CITY OF ALBUQUERQUE

RE: **ABC Building Expansion**
Grading and Drainage Plan
Engineer's Stamp Date: 9/20/18
Hydrology File: H14D001B

Based on the submittal received on 9/21/18, the grading and drainage plan cannot be approved for Grading Permit or Building Permit until the following are corrected and a complete resubmittal is made:

GRADING &
DRAINAGE PLAN

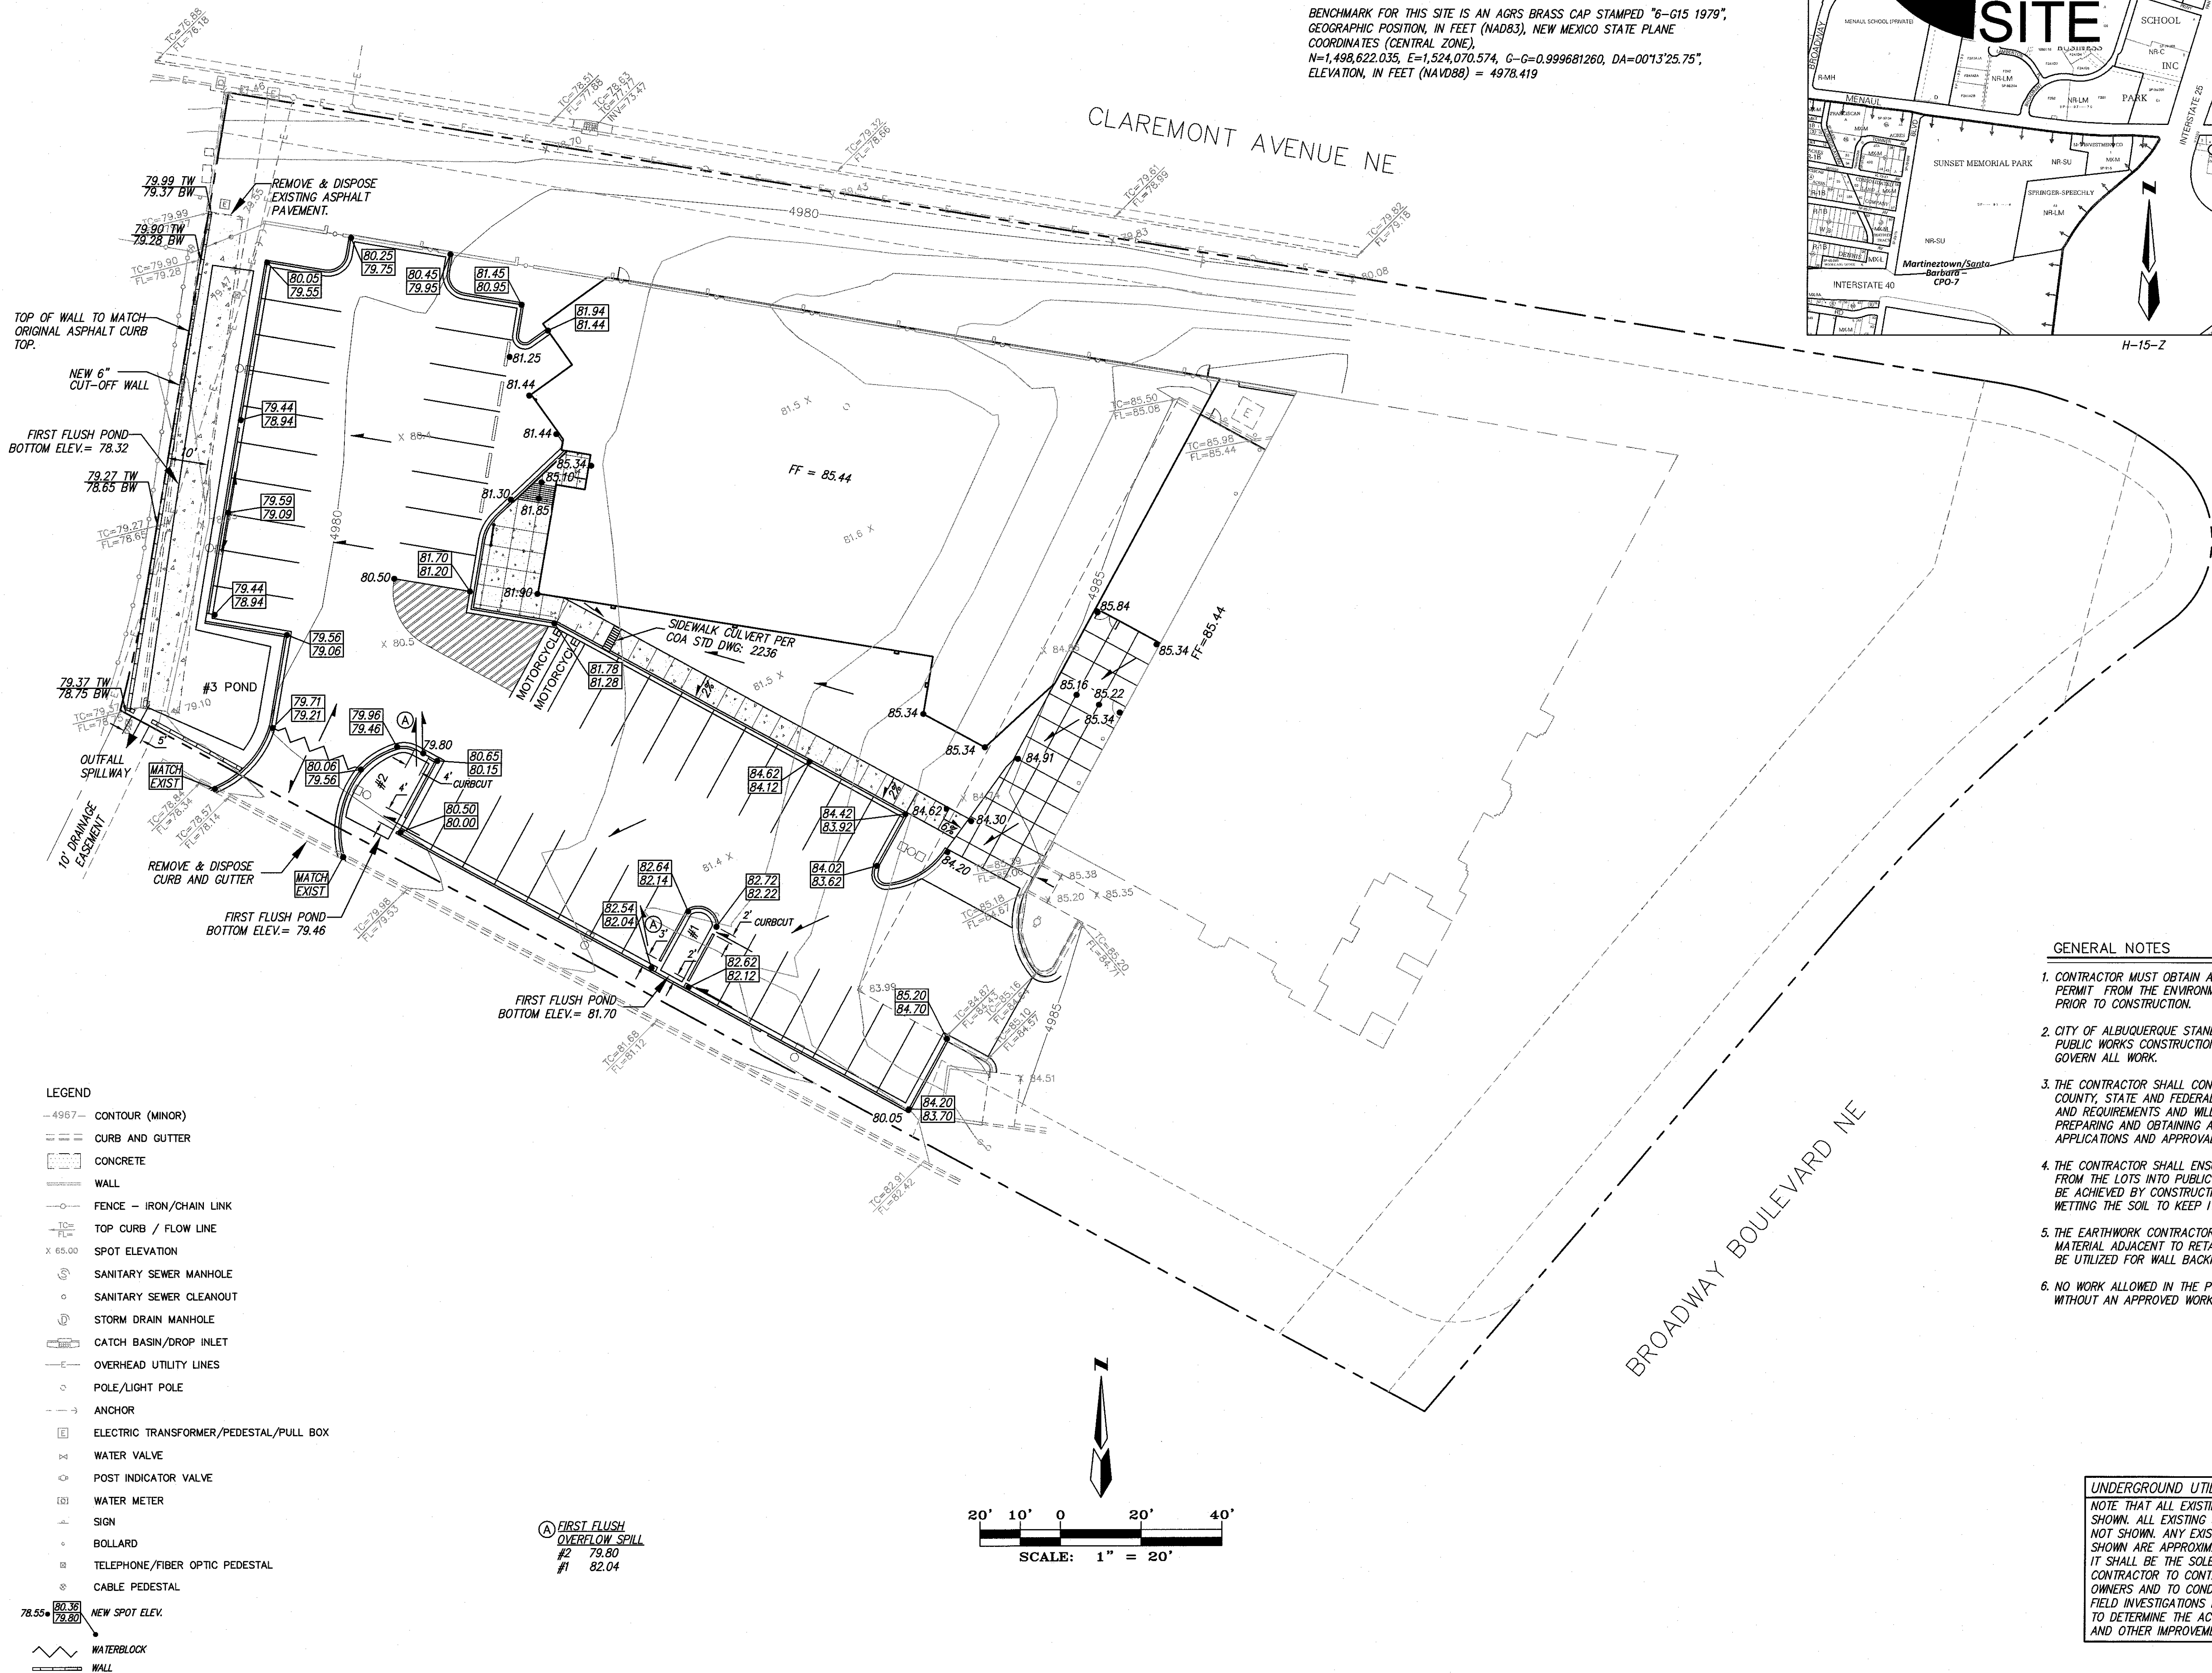
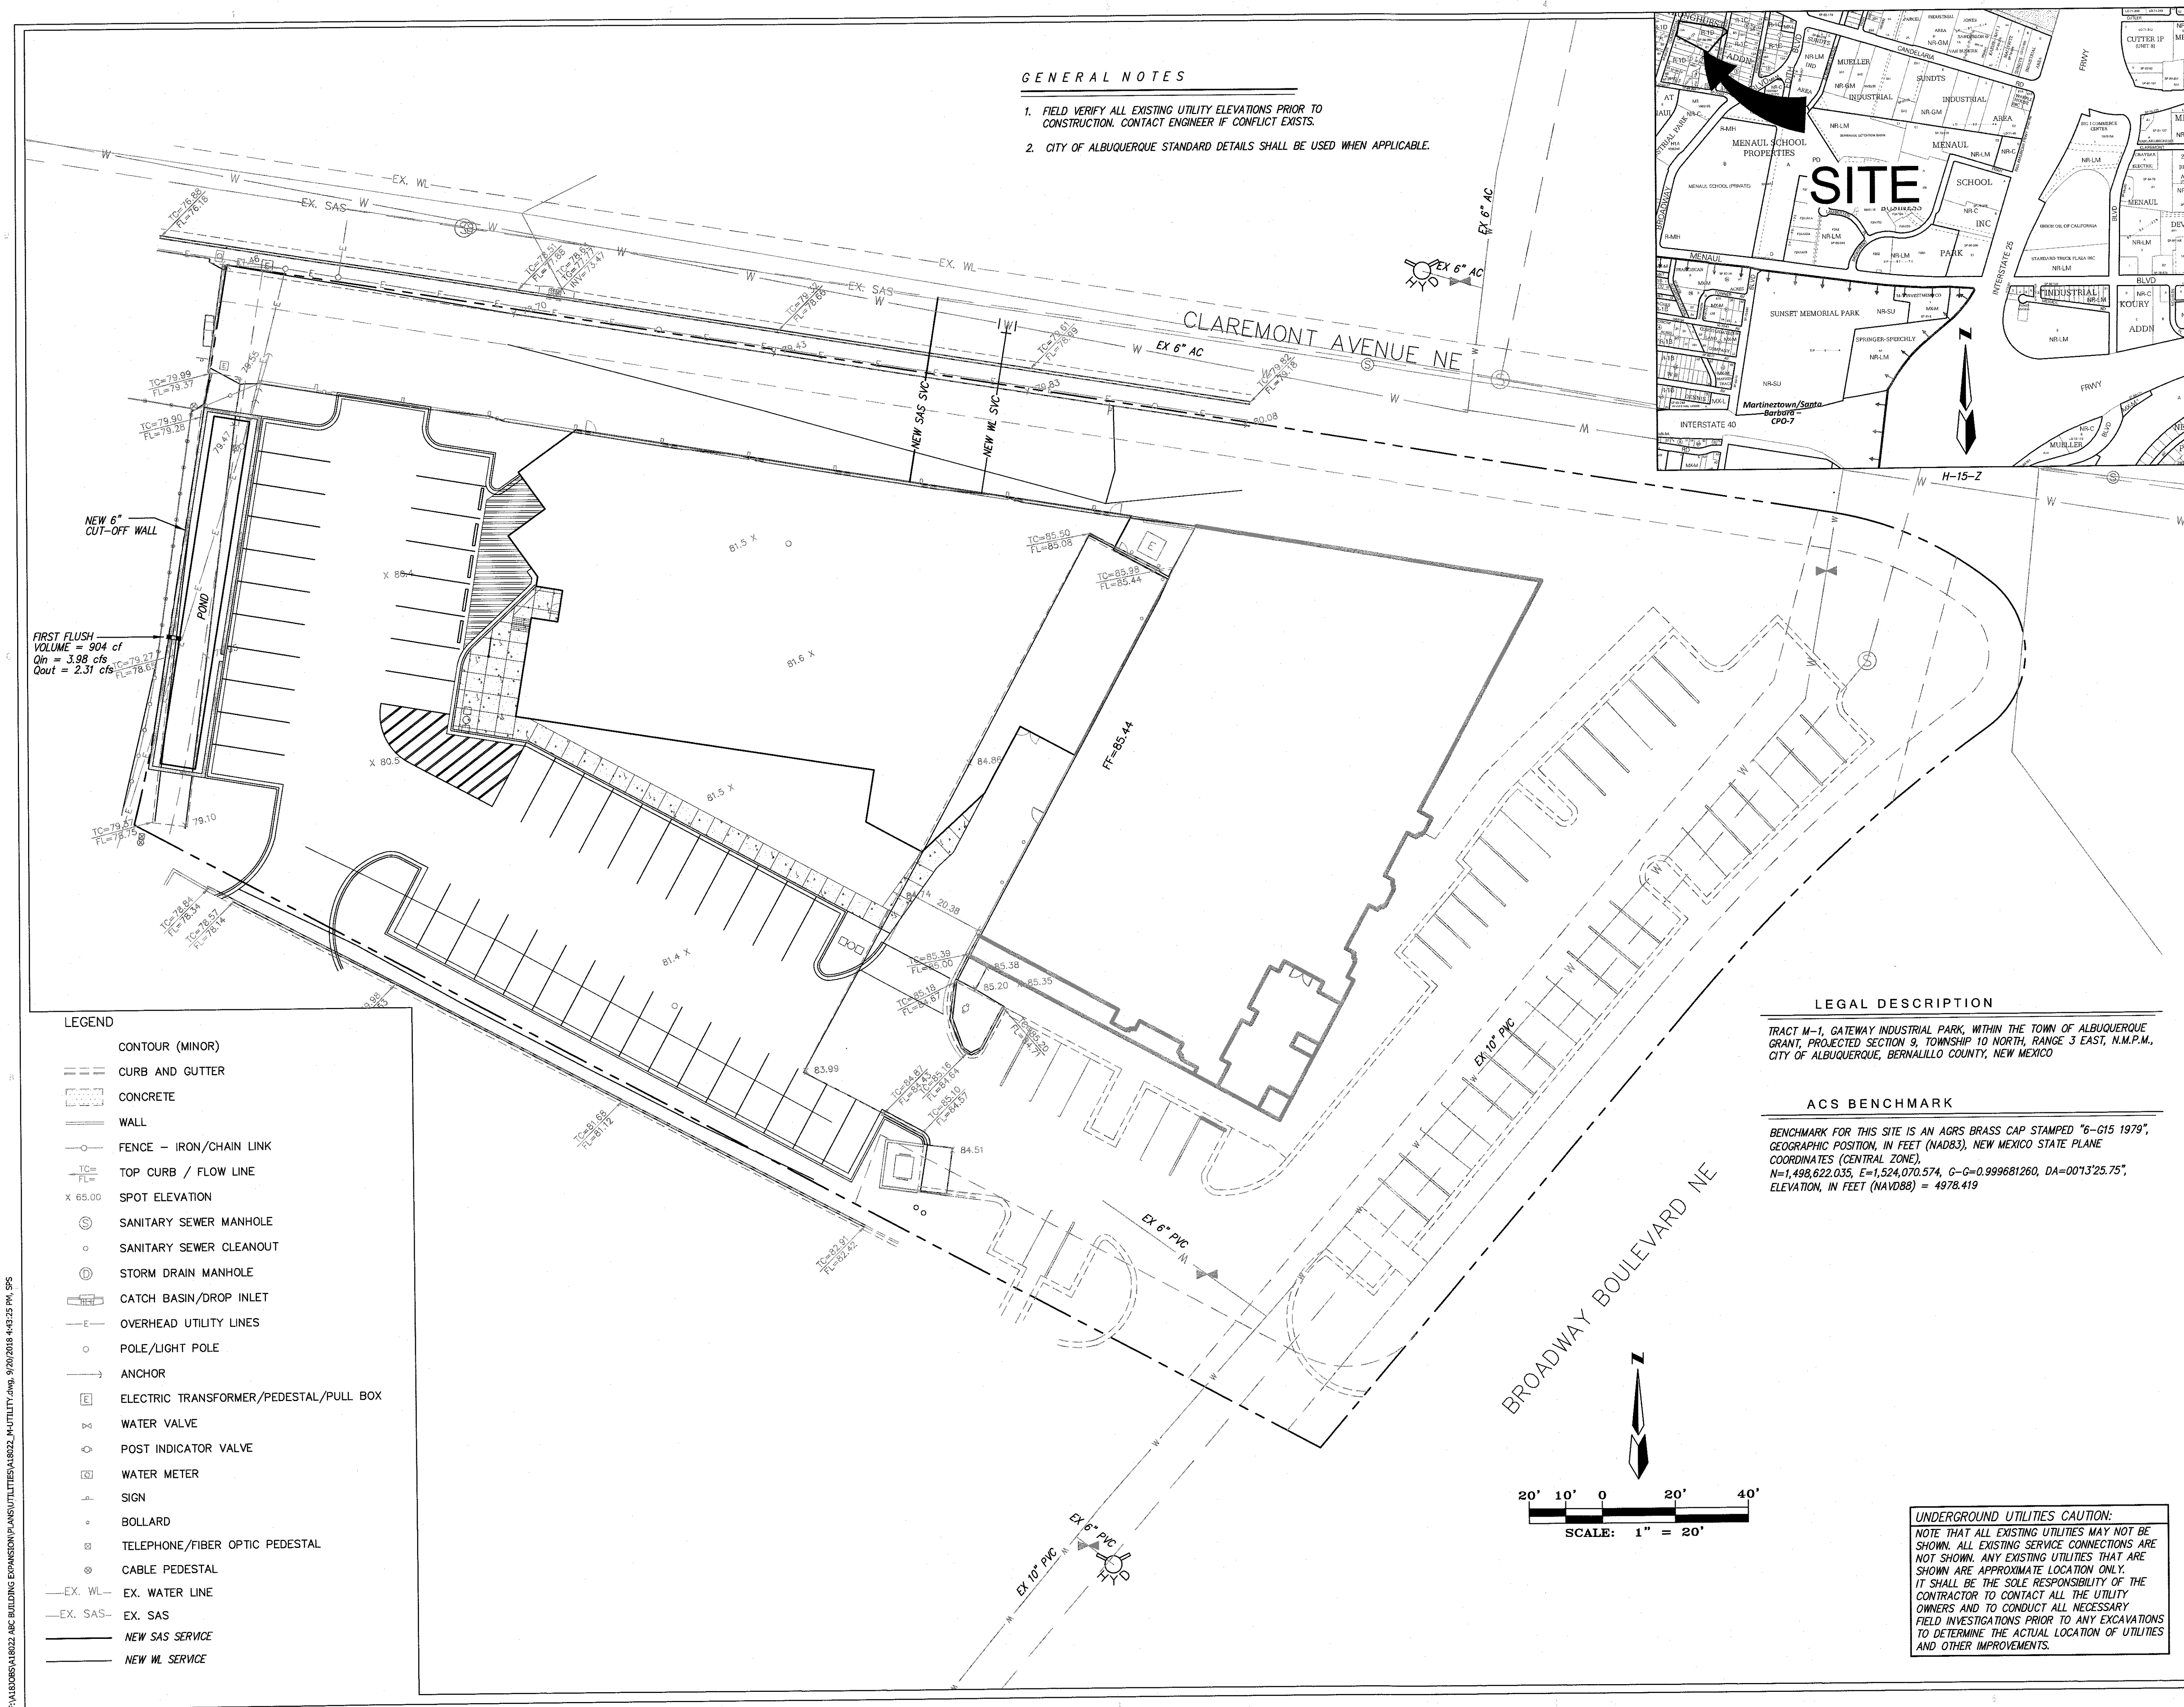
1. Provide written permission from the adjoining landowner (Tract H-1-A) for constructing the driveway access on their property (SW corner of this site).

2. Engineer's Certification, per the DPM Chapter 22.7: *Engineer's Certification Checklist For Non-Subdivision* is required.
